## TECHNICAL MEMORANDUM

To: Aaron Zimmerman  
Cc: David Roberts  
David Avitabile  
From: Maris Fry, P.E.  
Daniel VanPelt, P.E., PTOE  
Date: January 31, 2019  
Subject: 1000 4<sup>th</sup> Street, SW (ZC Case No. 02-38J)  
Response to DDOT Staff Report

This memorandum is a response to the DDOT Staff report dated January 22, 2019, regarding the 1000 4<sup>th</sup> Street, SW project (ZC Case No. 02-38J). In order to mitigate the impacts of the development, DDOT has requested a reduction in the number of vehicle parking spaces or an increase in strength of the TDM plan. The Applicant has agreed to strengthen the TDM plan as outlined in this memorandum. This memorandum also addresses updates to the Loading Management Plan and addresses additional DDOT comments.

Figure 1: Revised Ground Floor Site Plan

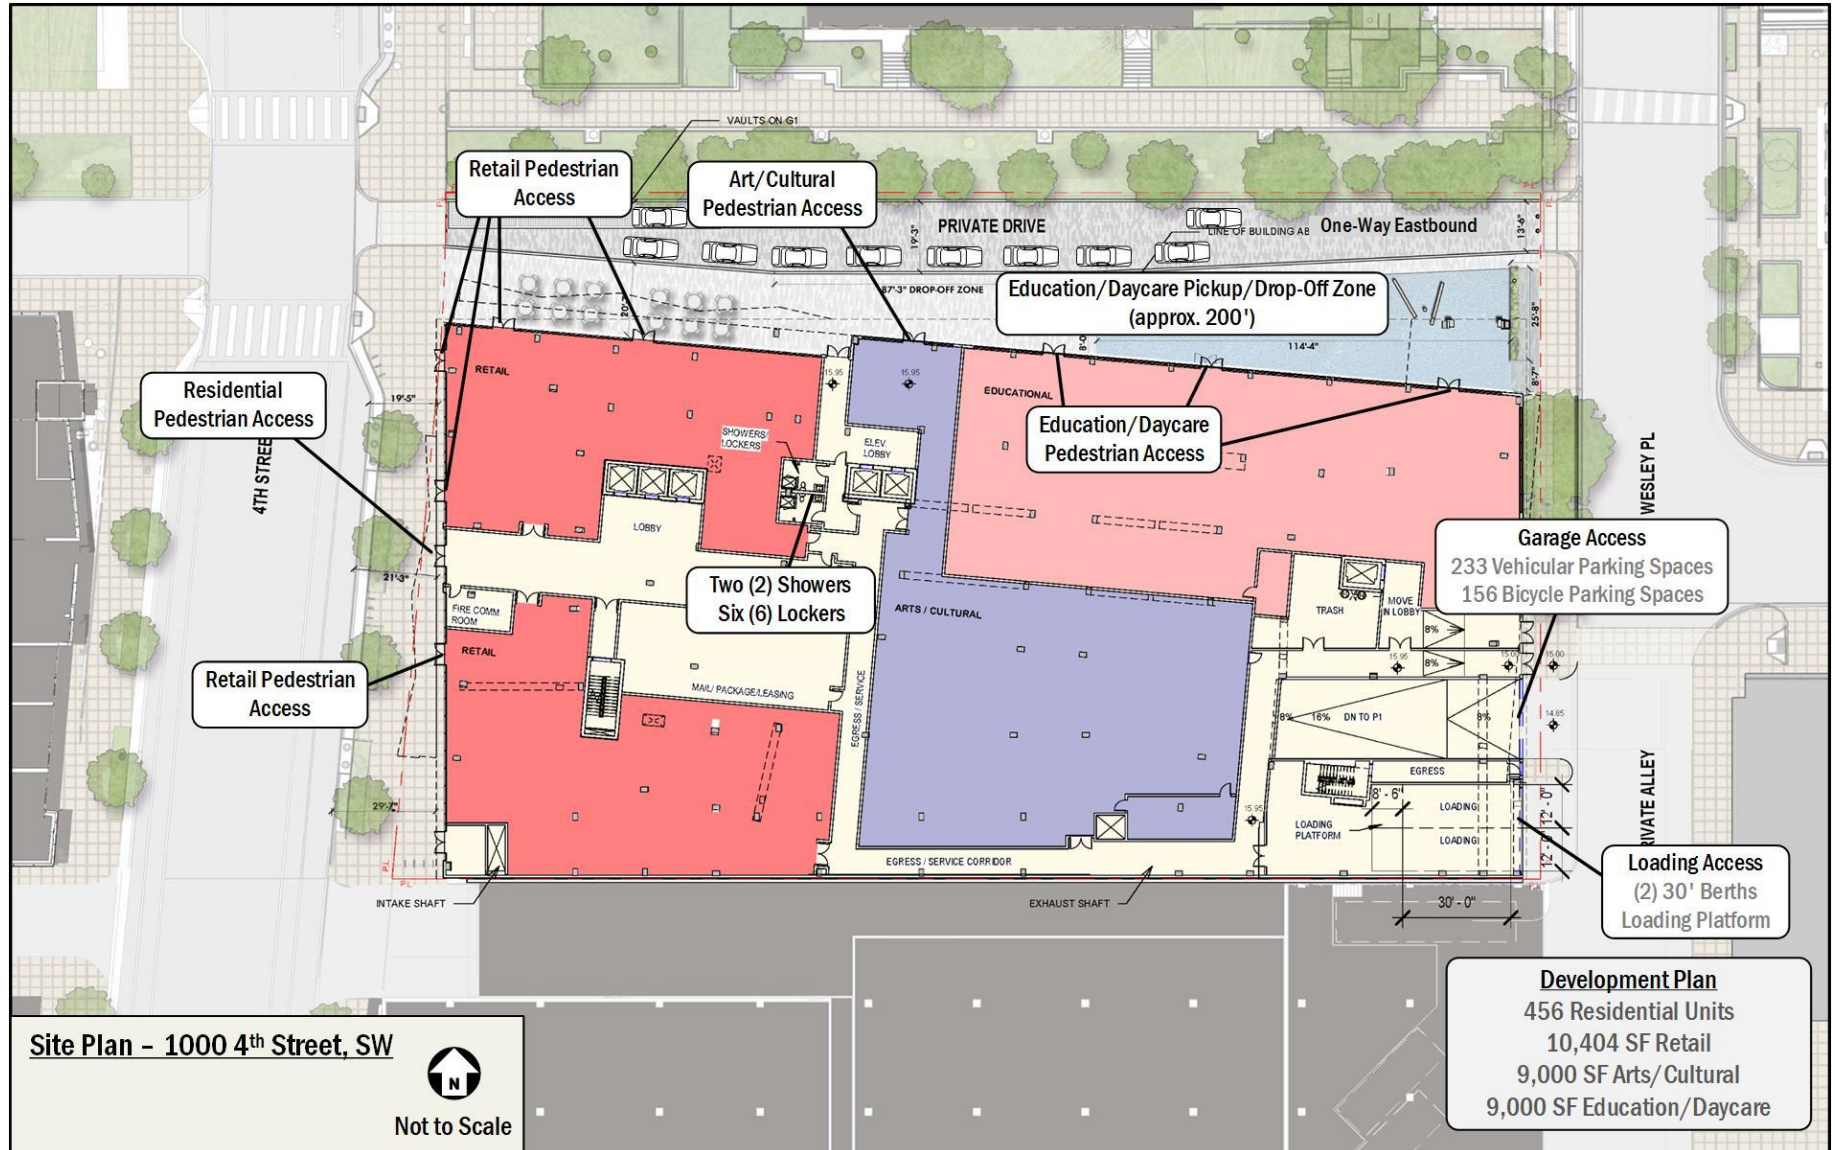
**DDOT Comment: The Ground Floor Plan (page 36 of Exhibit 22G3) does not currently show the two (2) ZR16-required loading platforms. A revised graphic should be provided with the platforms.**

- **Clarify in TDM Plan: Applicant will install a minimum of two (2) showers and two (2) lockers (per ZR16 requirements) for use by the building's non-residential uses;**

*Response: The ground floor plan has been updated and is attached to this memorandum as Figure 1.*

*Response: The revised TDM plan includes clarification that there will be two (2) showers and six (6) lockers provided within the site. Figure 1 shows the proposed location and design.*
